PCN# : P34EA
Issue Date : May. 06, 2013

DESIGN/PROCESS CHANGE NOTIFICATION

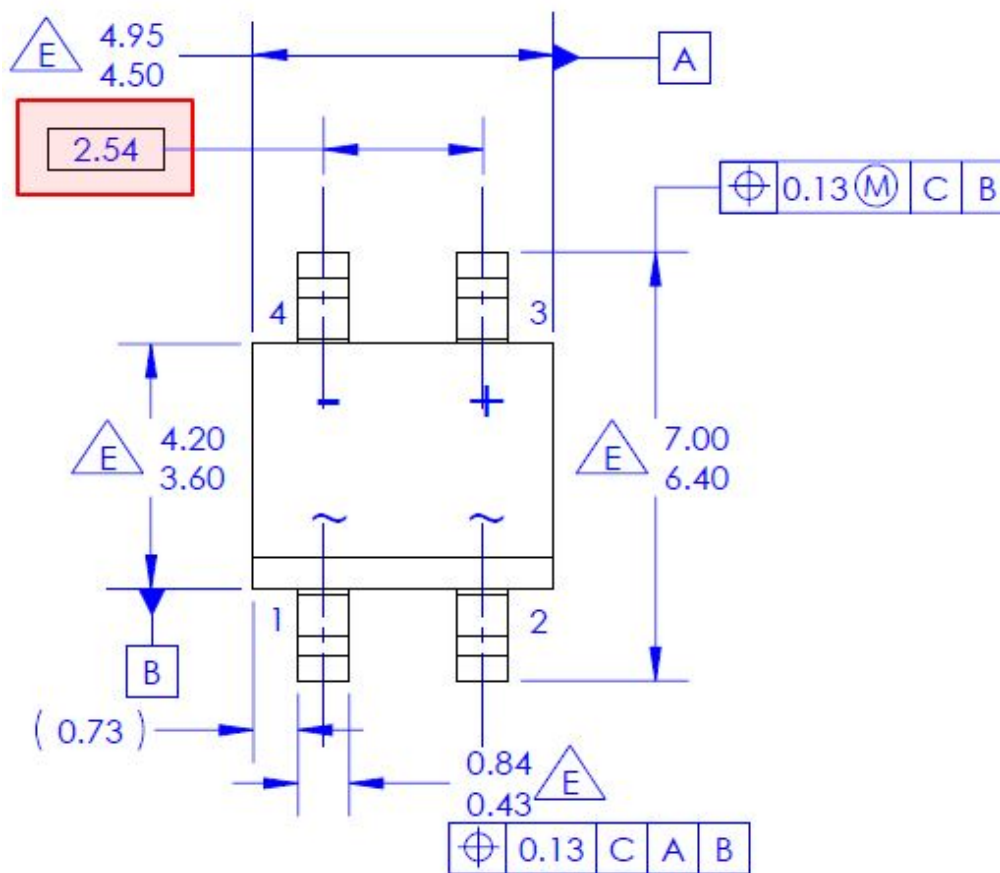
Description of Change (From) :
Package Lead pitch: 2.54mm typical
(with an implied tolerance of $\pm 0.13 = 2.41\text{mm min to } 2.67\text{ max}$)

Description of Change (To) :

Figure 10 is a detailed GD&T drawing of a mechanical part. The part is a rectangular block with four vertical pins (1, 2, 3, 4) and two horizontal pins (A, B). Dimensions are given in millimeters. Tolerances are specified for various features. A red box highlights the 2.70 dimension.

- Vertical dimensions on the left: 4.95, 4.50, 2.70 (highlighted), 2.20, 4.20, 3.60.
- Vertical dimensions on the right: 7.00, 6.40.
- Horizontal dimensions at the bottom: 0.84, 0.43.
- Feature Control Frames:
 - Feature A: $\oplus 0.13 \text{ (M) C B}$
 - Feature B: (0.73)
 - Feature C: $\oplus 0.13 \text{ C A B}$
